Technical Bulletin

Re: Video Input Module (VIM) Modifications For Improved Performance

Applies to: Marquee 8000/9000/8110/8500/8500LC/9500LC projectors manufactured before October 1995.

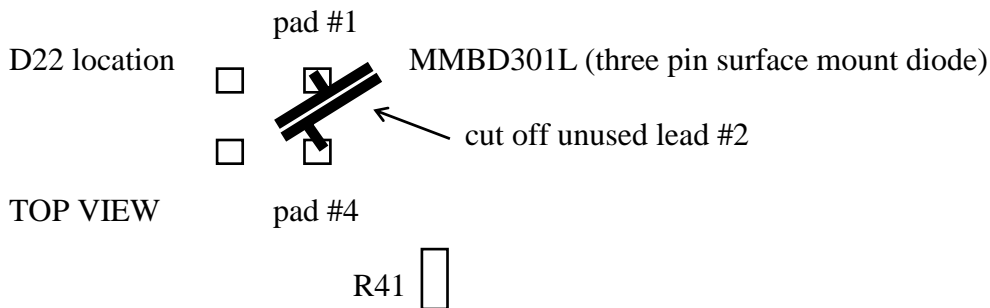
For symptom 2 (above):

- (a) Carefully remove D22 (unsolder it).
- (b) Solder a MMBD301L (Electrohome part no. 72-000533-06P) surface mount diode in the D22 location. See drawing below for details:
